FEDERAL PROJECT NO. STP-9901 (673)

ADDENDUM NO. 2

UNION/LINDELL BRIDGE REPLACEMENT

DATE: **10/15/26**

Sheet SW-04

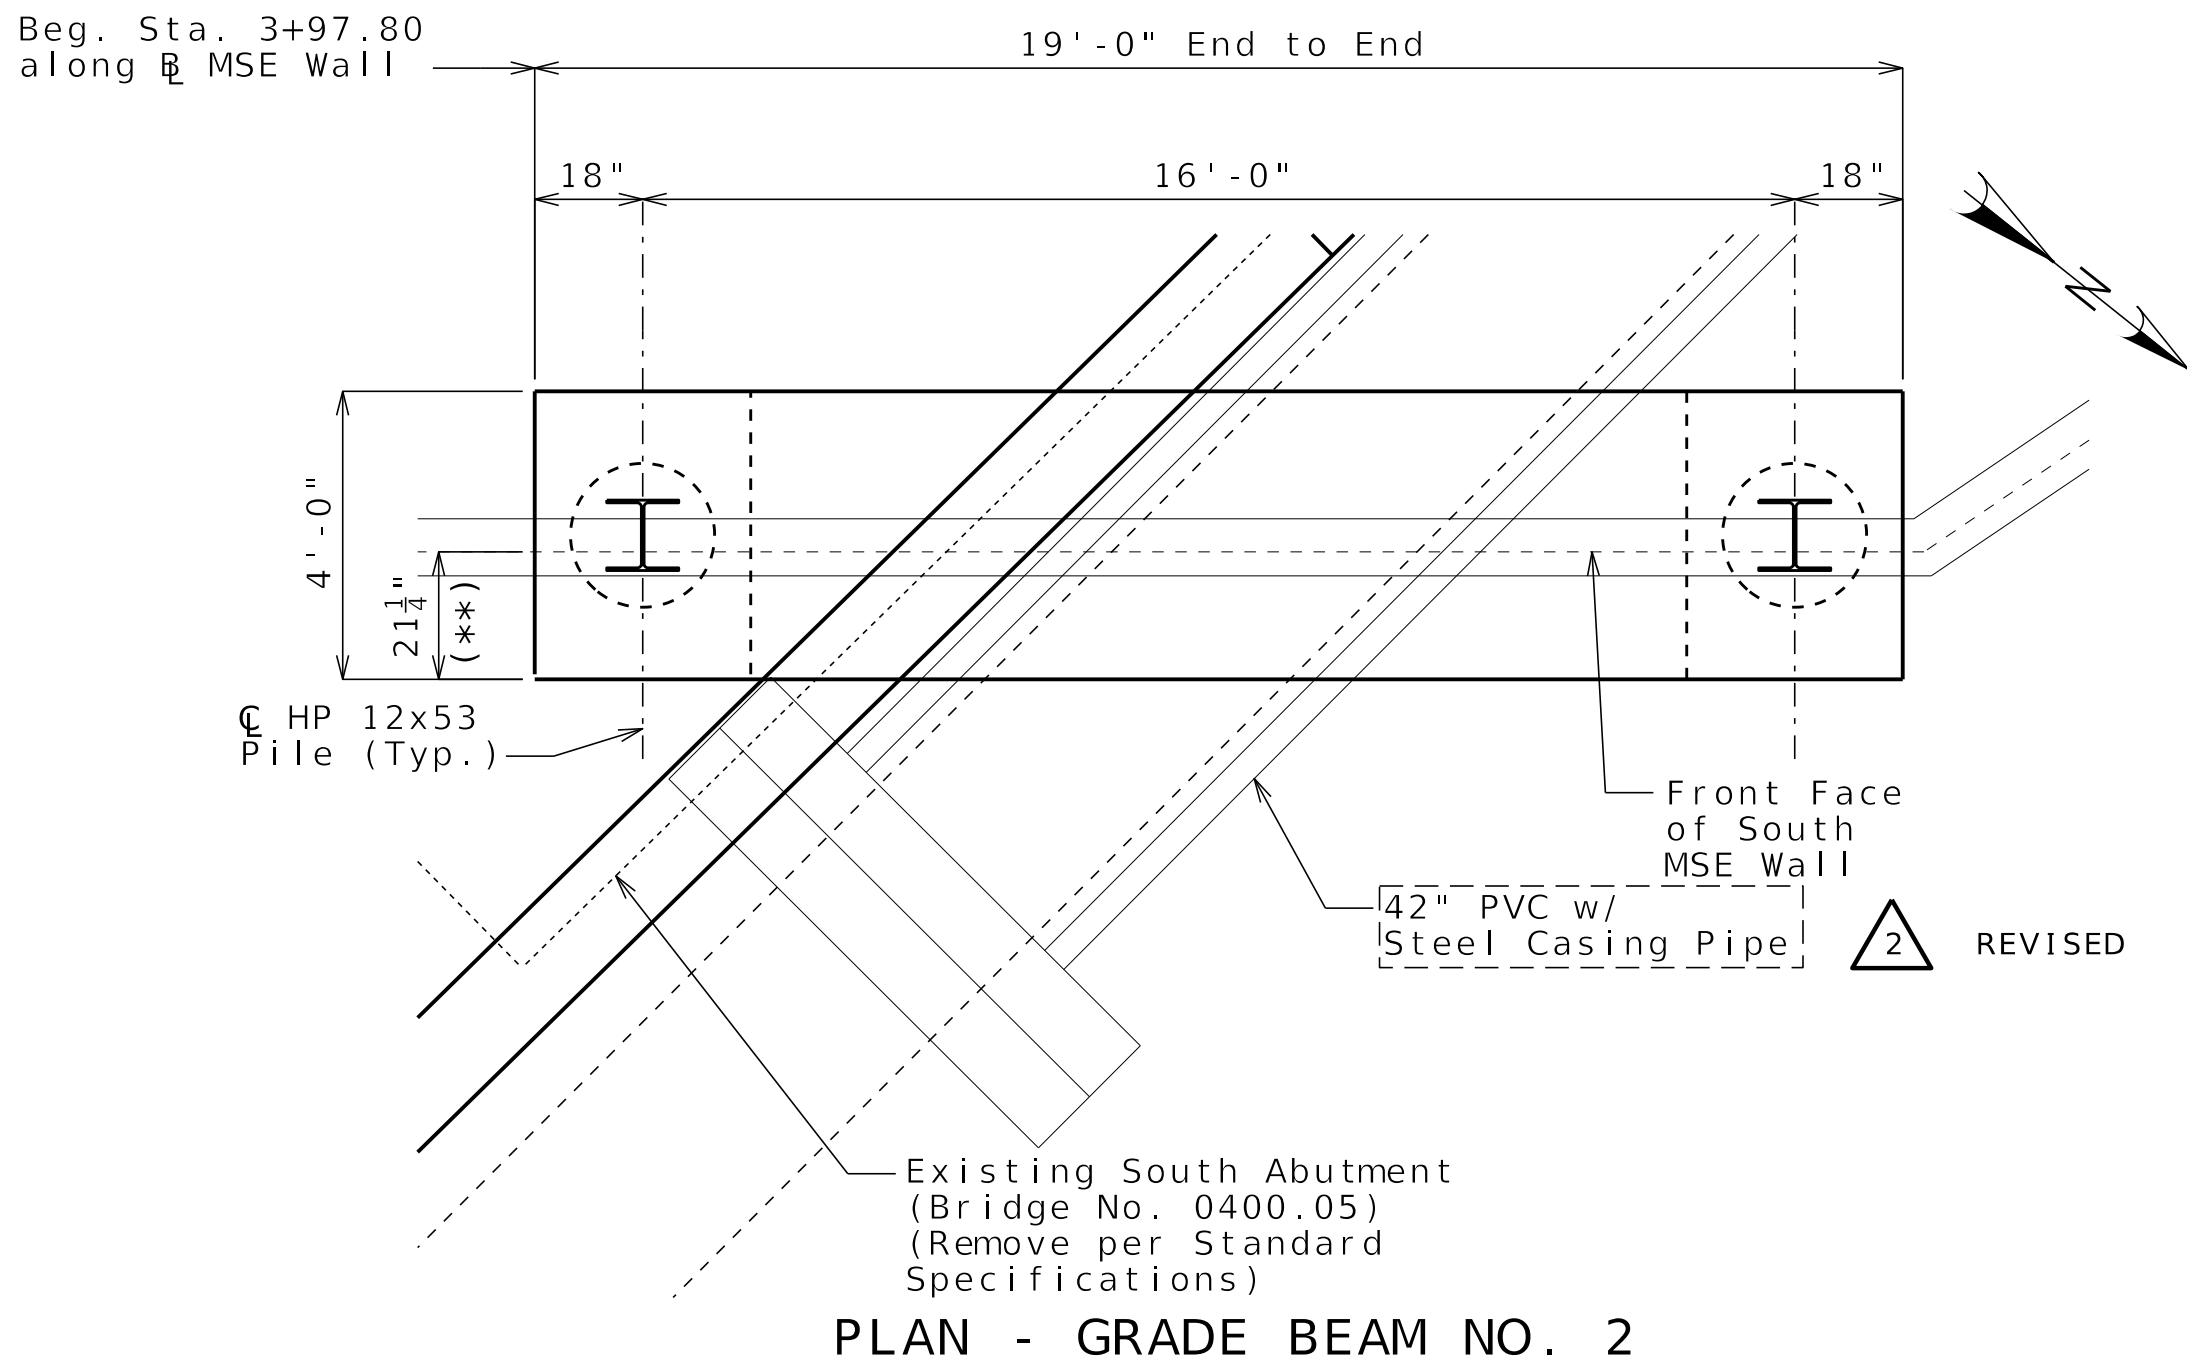
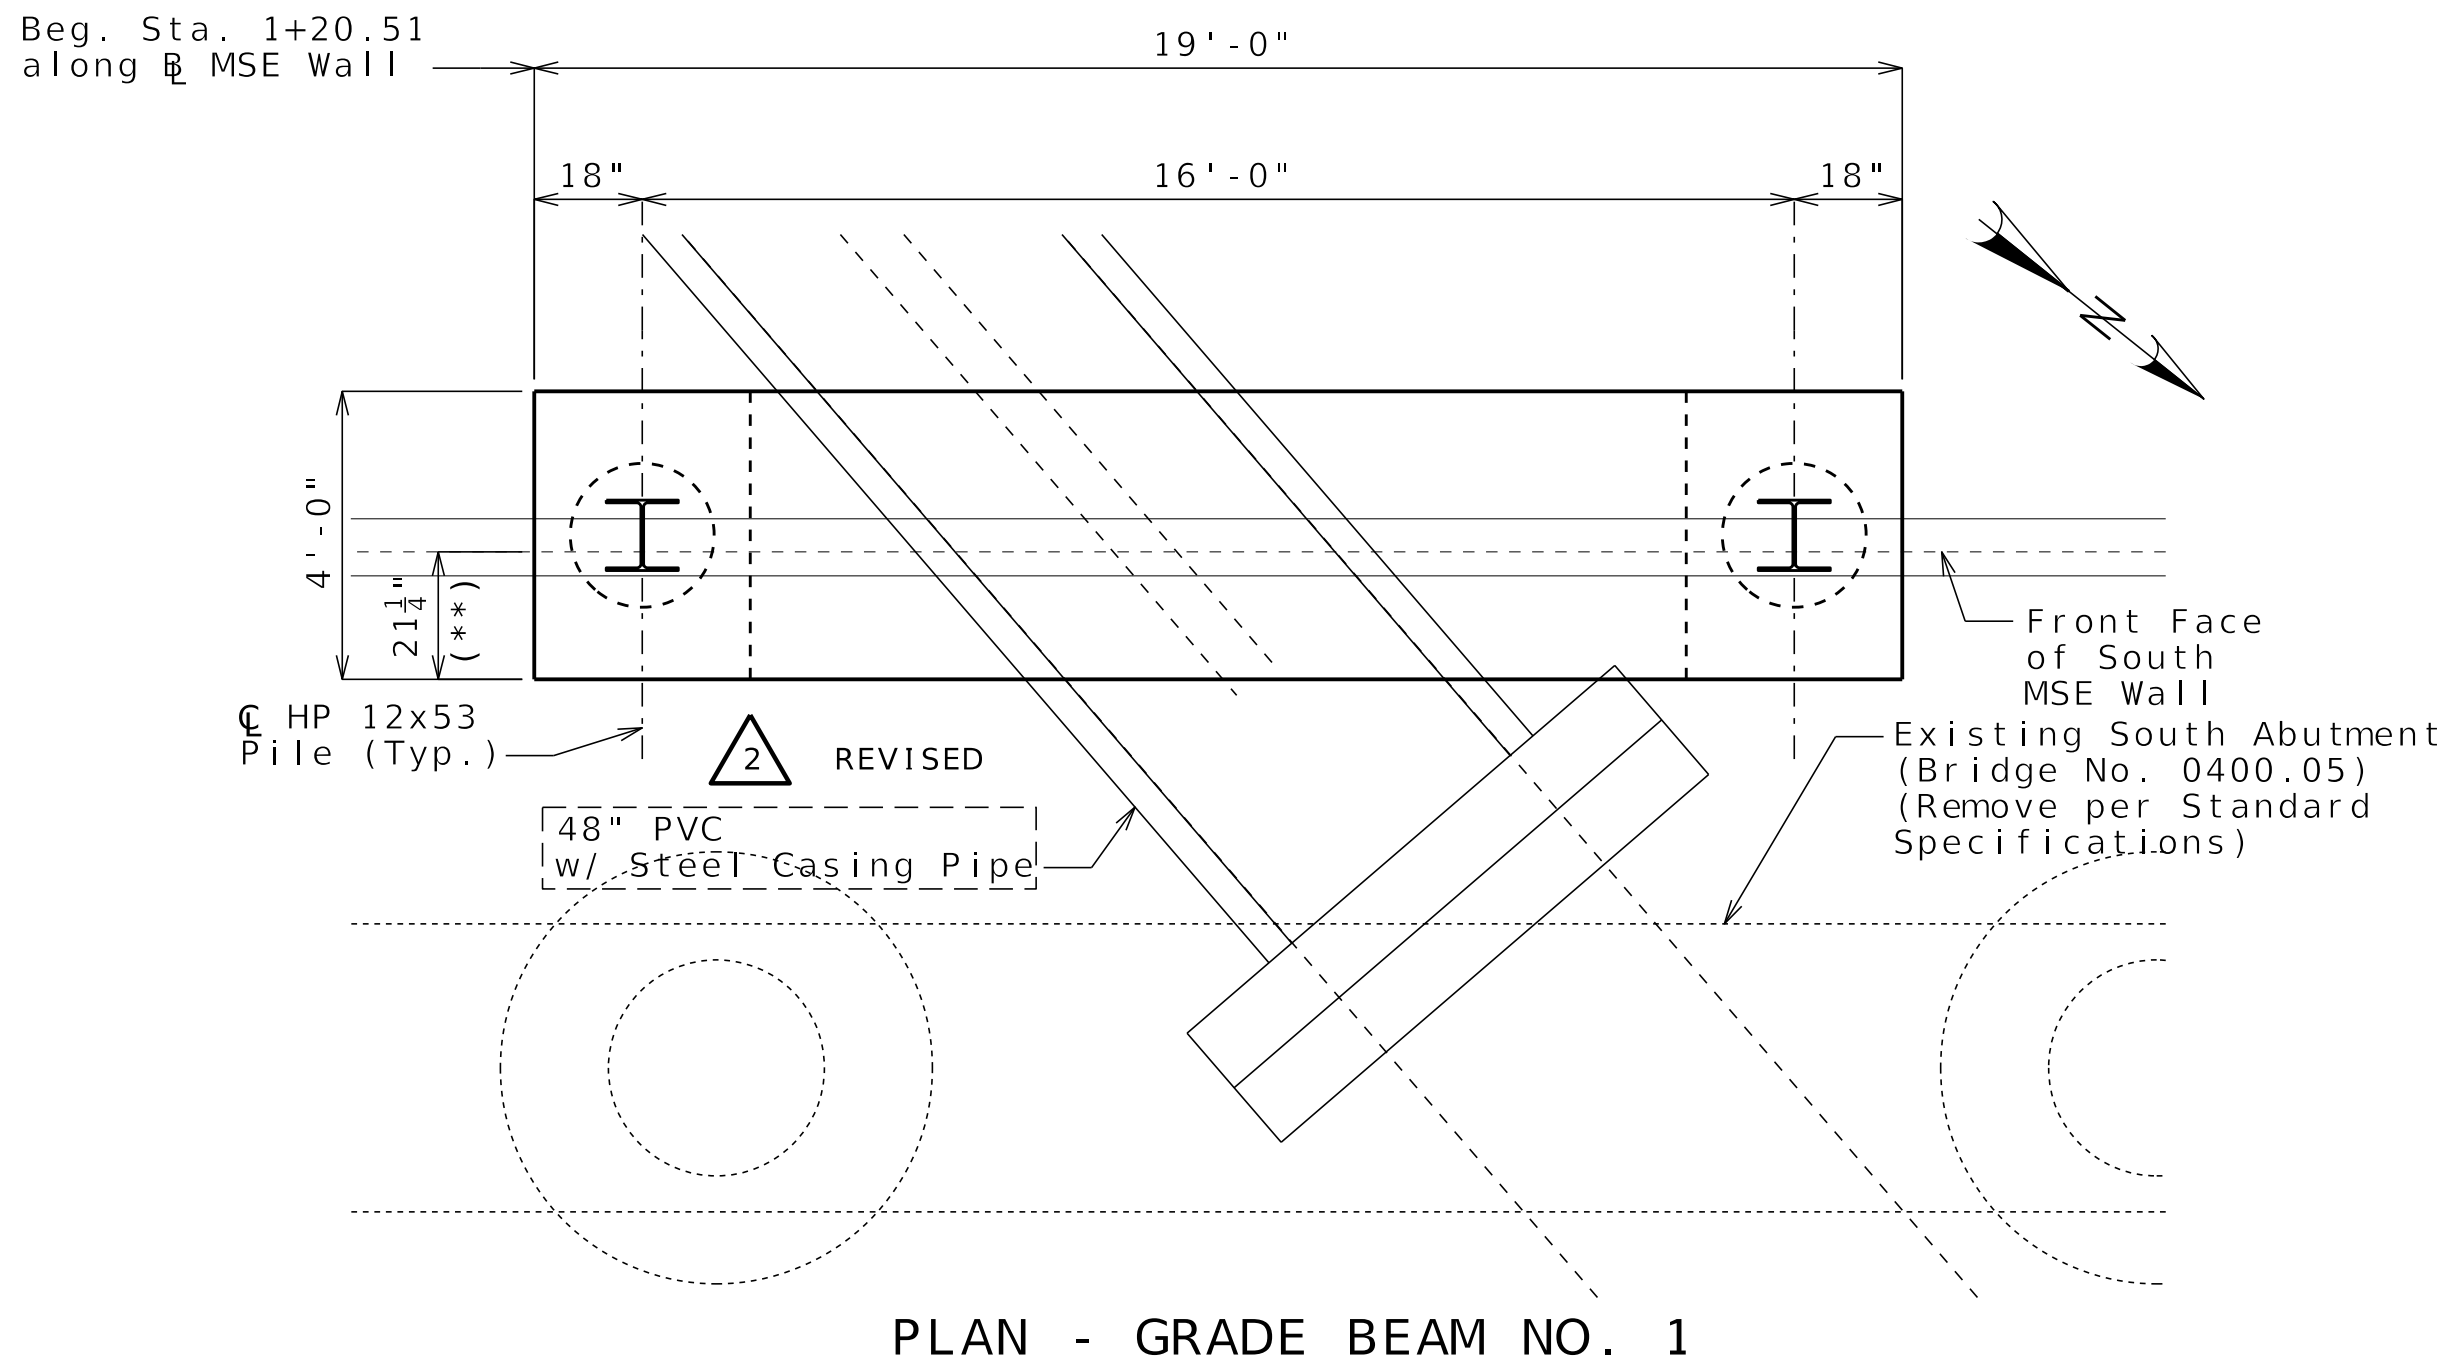
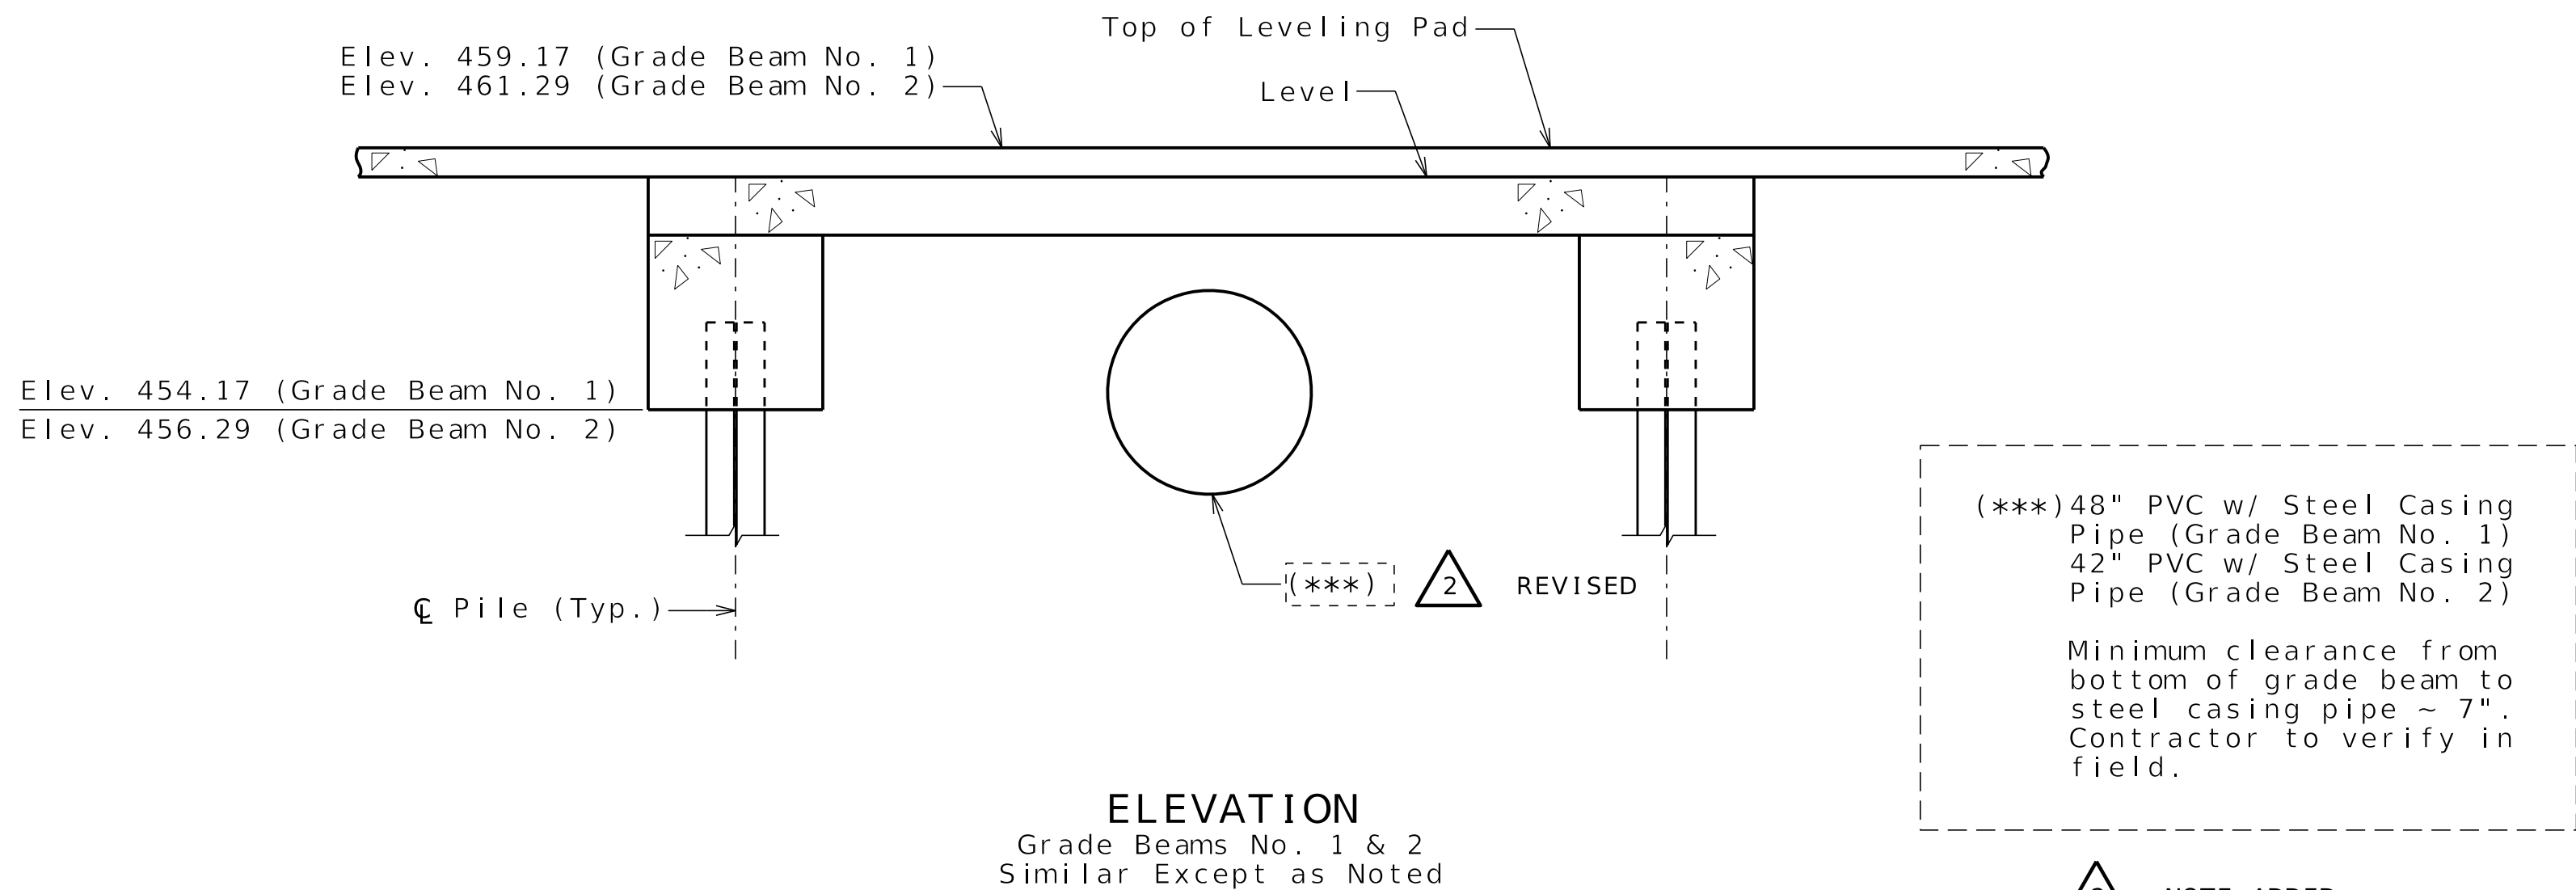
- The following plan sheets have been revised to reflect updated design calculations for storm runoff into the MSD system.
 - Cover Sheet, 2B.2, 2B.3, C4.6, C4.9, C7.2, C7.3, C7.4, C7.5, C7.6, C7.7, C7.8, C7.9, C7.11, CV7.12, C7.13, and C7.14
- The following plan sheets have been revised to clarify the MSE wall standpipe. All work related to the standpipe is considered incidental to the MSE wall.
 - SW-01, SW-04
